I-95 Reconstruction Project: Community Issues & Opportunities

Summary Report
January 2025

Prepared for:
Society Hill Civic Association

Figure 2 I-95 Access Points for the **Low Impact** Design Concept (Market Street to Morris Street)
base source: PennDOT

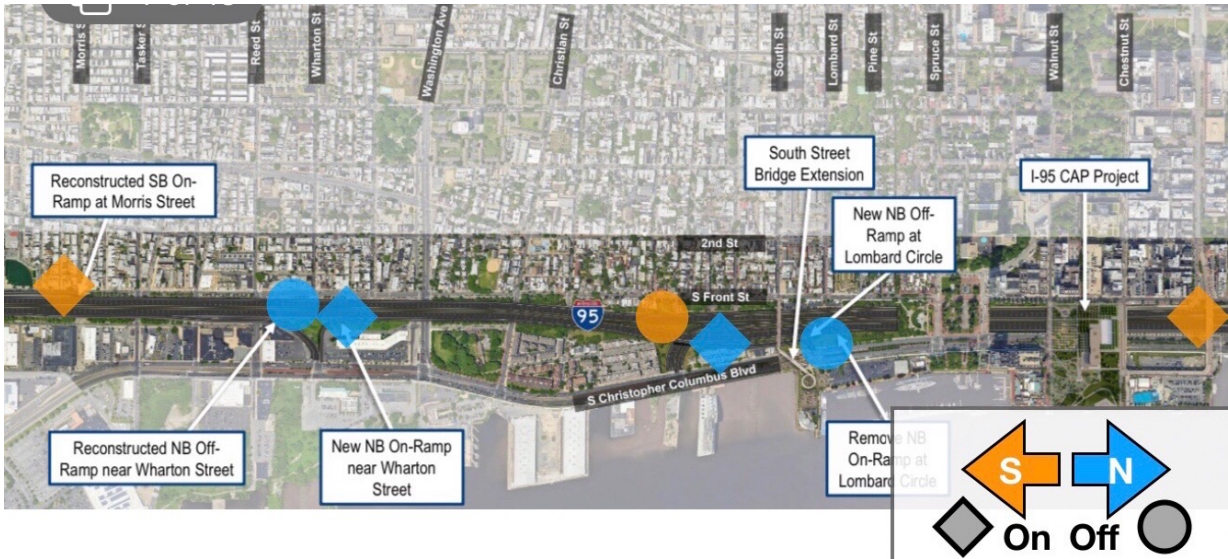
The High Impact design concept reduces the overall number of access points along I-95 between Market Street and Morris Street, while the Low Impact and Medium Impact concepts shift several of the existing access points to new locations. Each of the three concepts enlarges the interchanging functionality at Wharton Street, with the Medium Impact and High Impact options providing for all movements except a southbound off-ramp at this location. It has been indicated on PennDOT plans that all these access points would be focused toward Delaware Avenue.

While any shifting of access points will alter the traffic patterns to, from and through each of the adjoining communities, their consolidation toward Delaware Avenue will run the additional risk of increasing general traffic levels on this corridor and creating localized heavy-traffic locations both along Delaware Avenue and on the intersecting (i.e. east-west) cross-streets that connect it with the heavily populated areas of Central and South Philadelphia.

Figure 5 Summary of Potential Issues with Current I-95 Design Concepts (Market Street to Morris Street) base source: PennDOT

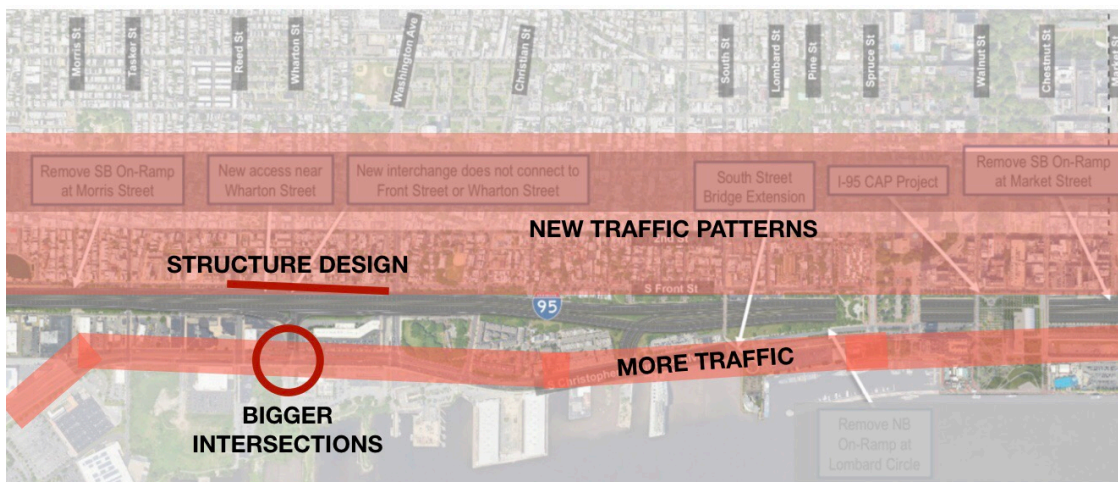
Figure 5 summarizes in diagrammatic form the concerns that could arise from these changes. Specifically they include:

- New traffic patterns through the residential areas nearest to I-95, especially the corridors of Front Street and 2nd Street which could see significant shifts in traffic levels along their lengths

- Significantly increased traffic levels on Delaware Avenue resulting from the consolidation of access points to face only eastward, as drivers will need to use Delaware Avenue to reach these access points particularly with the Medium Impact and High Impact design concepts

- Increase in traffic on the cross-streets connecting the residential and commercial areas of Central and South Philadelphia with Delaware Avenue
- Larger (and more difficult to traverse) intersections along Delaware Avenue as associated with its increased reliance as an I-95 access corridor, particularly at the location of the consolidated Wharton Street interchange included in the Medium Impact and High Impact design concepts

- Potential concerns with the design of the west (i.e. community-facing) sides of the proposed new ramps and enlarged interchanges (particularly at Wharton Street) as these risk large unbroken expanses of infrastructure not generally conducive to community amenity or walkability.
